PLANNING AND ZONING CASE CHECKLIST

P&Z CASE # 22021-057 P&Z DATE 01/11/22 CC DATE 01/18/22 APPROVED/DENIED
ARCHITECTURAL REVIEW BOARD DATE _____ HPAB DATE _____ PARK BOARD DATE _____

PROJECT NUMBER: Z2021-057
 PROJECT NAME: Zoning Change (AG to PD) for High Gate
 SITE ADDRESS/LOCATIONS:

12/20/2021: Z2021-057; Zoning Change (AG to PD) for High Gate
 Please address the following comments (M= Mandatory Comments; I = Informational Comments)

CONCEPT PLAN
HIGH GATE
 264.5 Acres
 Rockwall, Texas

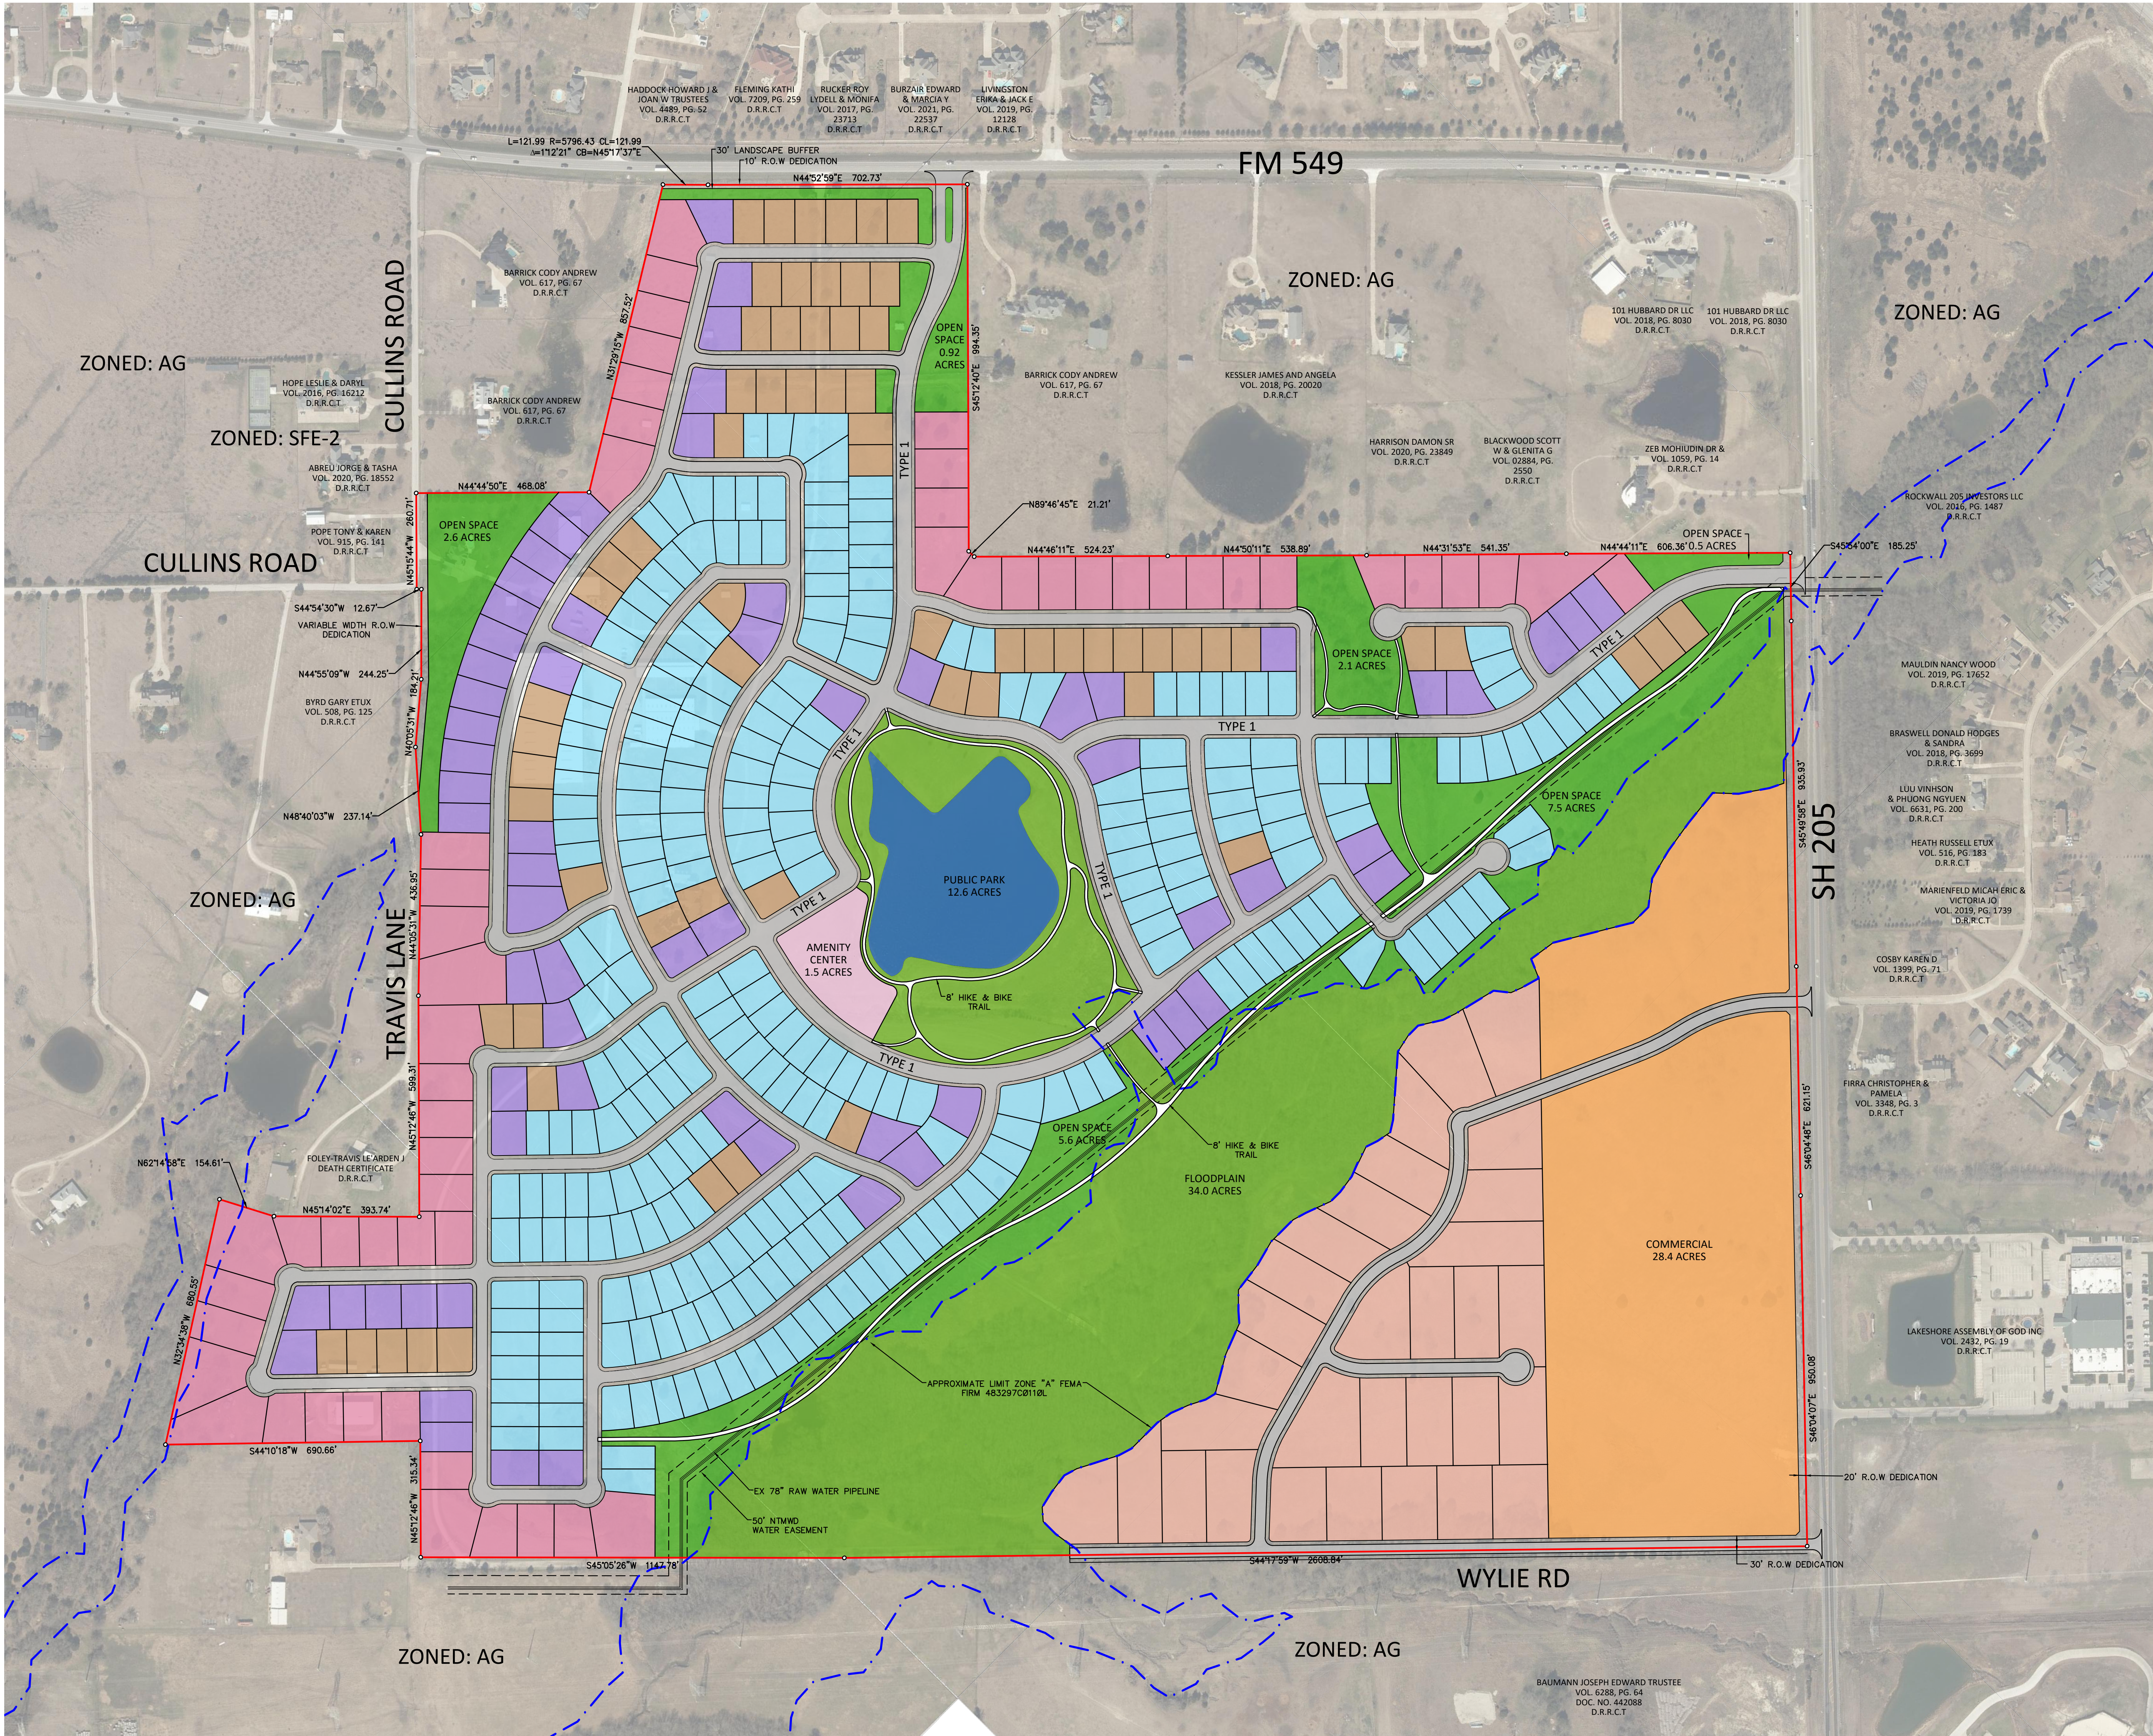
M.6 Based on the submitted Concept Plan, please make the following corrections and resubmit the updated plan by January 4, 2022:

- (1) Open Space. The minimum open space required for this development is 52.902-acres (i.e. 264.51 x 20%); however, only 51.50-acres have been provided. Please revise the concept plan to add an additional 1.402-acres.
- (2) Open Space Proximity Requirements. The Unified Development Code (UDC) requires that all residential lots less than 12,000 SF be within 800-feet of a park or open space. Please provide a separate exhibit that demonstrate that all Type 'C', 'D' & 'E' lots are within 800-feet of an open space.
